Model: N-C3		Date: 10-Dec-10	No.: RD093001
Subject: Service Manual Correction		Prepared by: F.Noguchi	
From: 2nd Overseas Tech Support Sec. 2nd PQM Dept			
Classification:	<input type="checkbox"/> Troubleshooting	<input type="checkbox"/> Part information	<input type="checkbox"/> Action required
	<input type="checkbox"/> Mechanical	<input type="checkbox"/> Electrical	<input checked="" type="checkbox"/> Service manual revision
	<input type="checkbox"/> Paper path	<input type="checkbox"/> Transmit/receive	<input type="checkbox"/> Retrofit information
	<input type="checkbox"/> Product Safety	<input type="checkbox"/> Other ()	<input type="checkbox"/> Tier 2

Revisions made to the N-C3 Field Service Manual (FSM) and Technical Training Package (TTP)

This RTB contains the following revisions (additions, deletions, corrections), which have been **highlighted in bold** below:

3. Preventive Maintenance > PM Tables > Main Machine

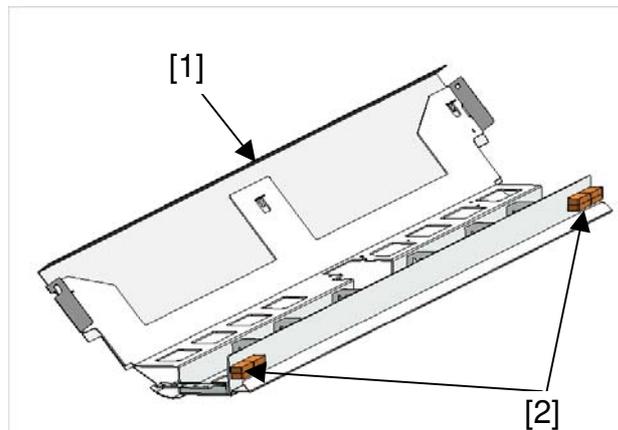
● Added:

Description	Q'ty	PM Interval		PM	Comments
		Metric	Feet		
Development					
Magnet (Idle Registration Roller panel)		5.5	18.0	C	vacuum cleaner

DEVELOPMENT AND TONER SUPPLY > ID Sensor Operation at Warm-up

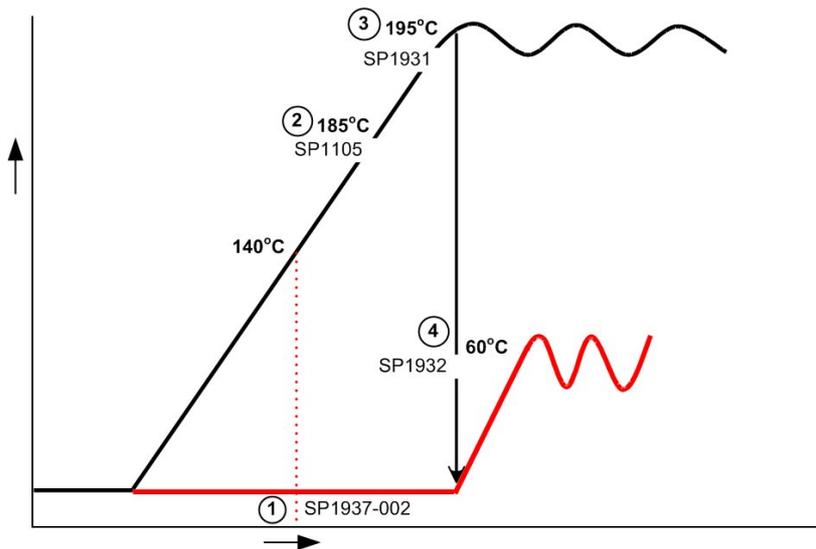
- Corrected:

DEVELOPMENT AND TONER SUPPLY > Warm-up

- If the fusing temperature is below 50°C (122°F) after the machine is powered on (or returns from the auto off mode or sleep mode), the machine starts and runs the warm-up cycle for 50 sec. to prevent the occurrence of dirty background on the first copy.
 - Drum motor
 - Quenching lamp
 - CGB power pack
 - Separation power pack

FUSING > Fusing Warm-up 2

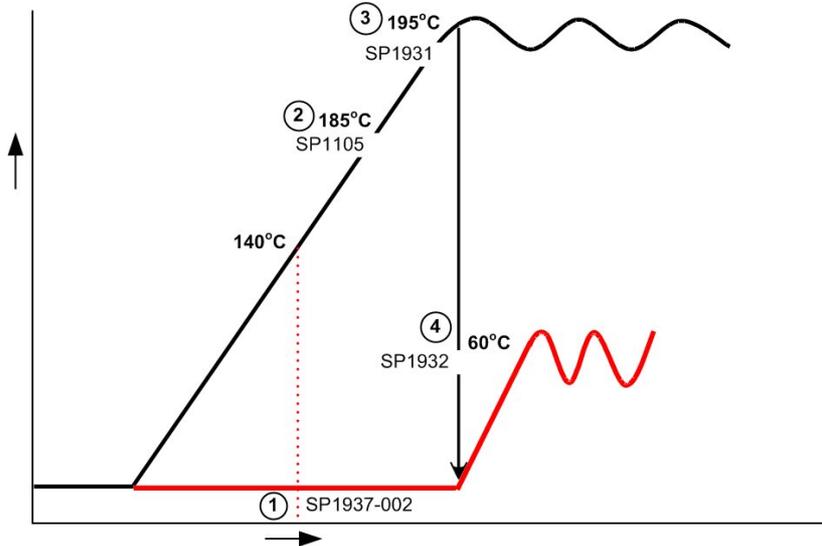
- Corrected:

- ❑ If it took less than **85 seconds** for the hot roller to get to **140°C**, then copying can start when the hot roller gets to 185°C (this is 10°C less than the copy start temperature).

FUSING > Fusing Warm-up 3

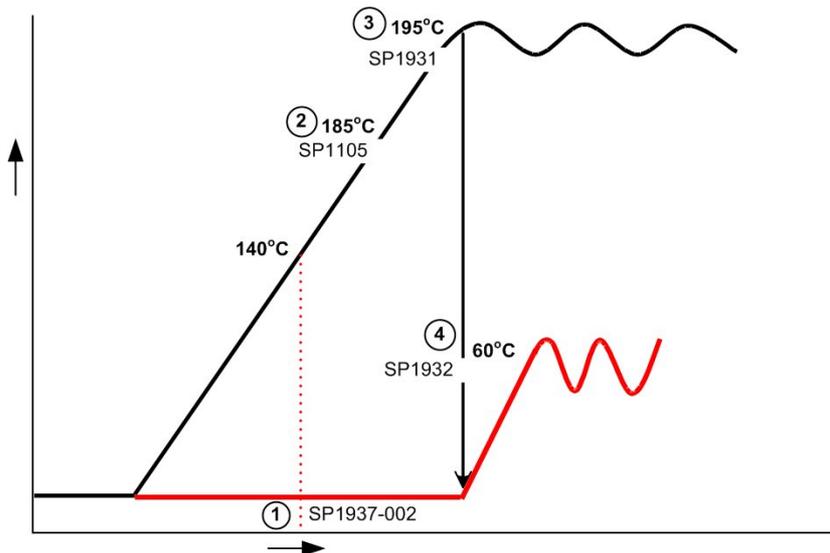
- Corrected:

- ❑ When the hot roller temperature gets to its target (195°C), the fusing unit idles until the pressure roller gets to its target temperature (60°C).
- ❑ If it took longer than **85 s** for the hot roller to get to **140°C**, copying cannot start until the hot roller gets to its target temperature.

FUSING > Fusing Warm-up 3

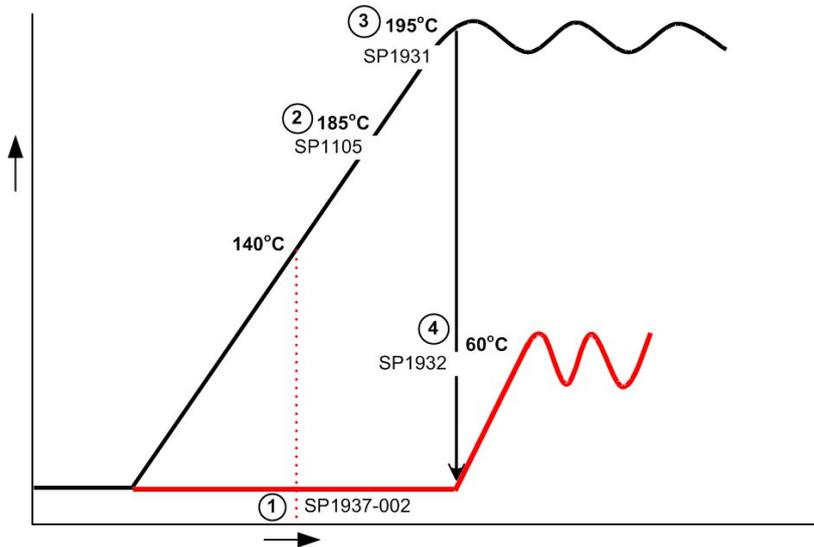
- Corrected:

- During standby mode, the hot roller and pressure rollers are kept within $\pm 5^{\circ}\text{C}$ of their target temperatures.
 - ◆ Hot roller: 195°C
 - ◆ Pressure roller: 60°C

2. Installation > Roll Feeder (D503/D504) > Roll Feeder Installation Procedure
 > Connecting the Main Machine and Roll Feeder

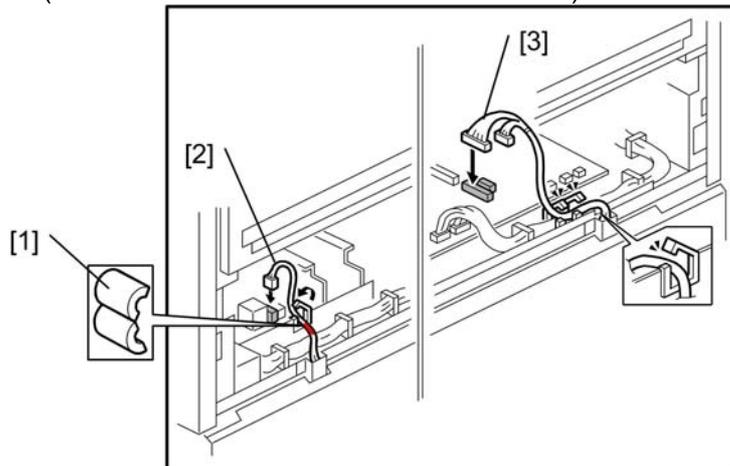
8. Route the harness ( x 2) through bracket [5] and then attach the bracket ( x 2).
 (Use one screw from the accessories).

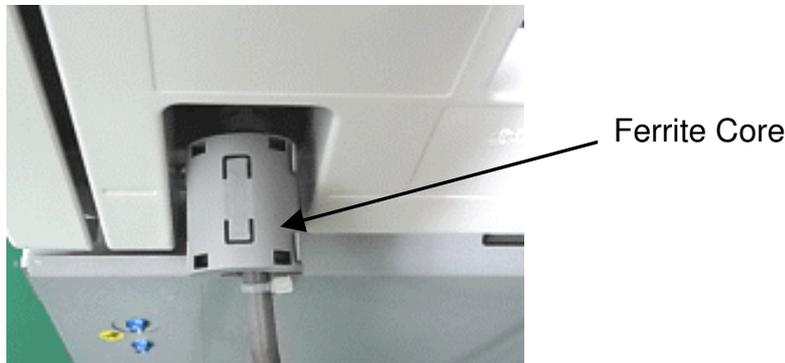
Change: The ferrite core was added as a service part for the mainframe. (It is attached to the power supply cord from the beginning of mass-production).

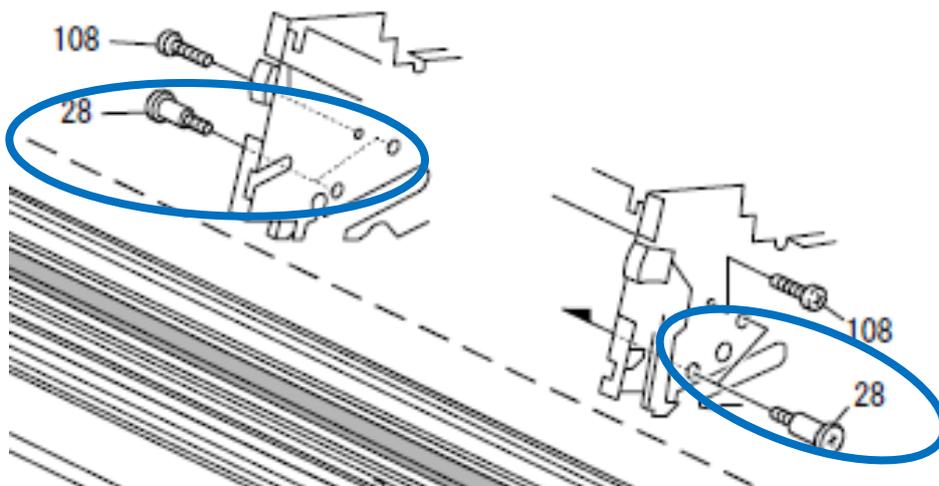
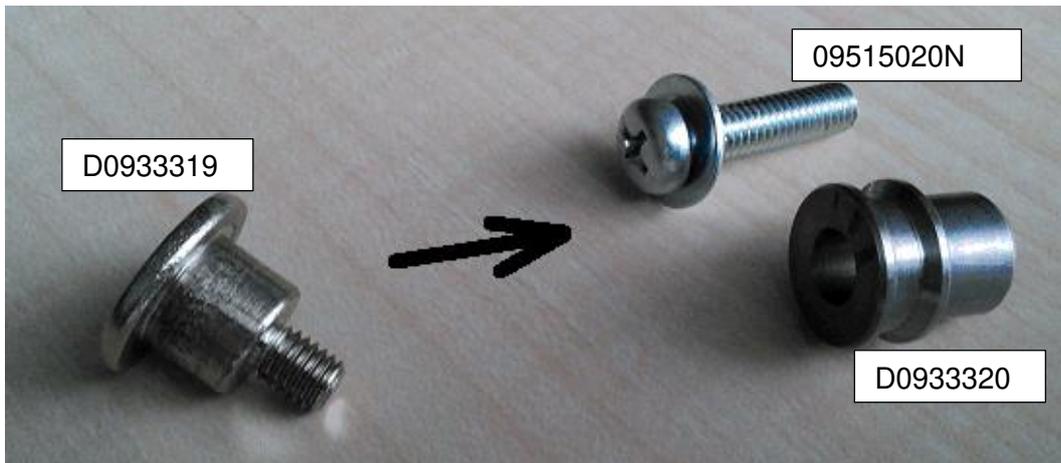
Change/Reason: Screws used for the development unit were changed to gain higher precision in assembling the unit.

Old P/N	New P/N	Description	Q'ty	Page	Index
D0933319	D0933320	COLLAR:DEVELOPMENT UNIT	4	27	28
	09515020N	SCREW:POLISHED ROUND:M5X20	4

NOTE: When replacing the above screws, replace both types of screws as a set.

Replacement Procedure

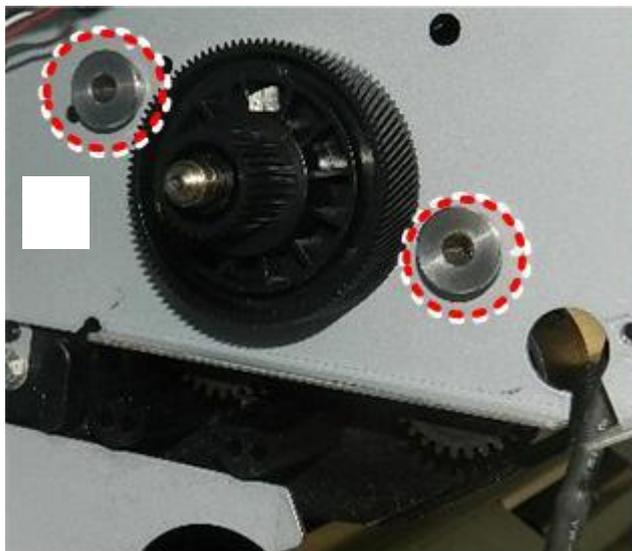
(The example shown below is the procedure for the left hand side. The procedure is the same for the right hand side.)

1. Install the collar first, then determine the position of the development unit.

2. Fasten the screws (M5x20).
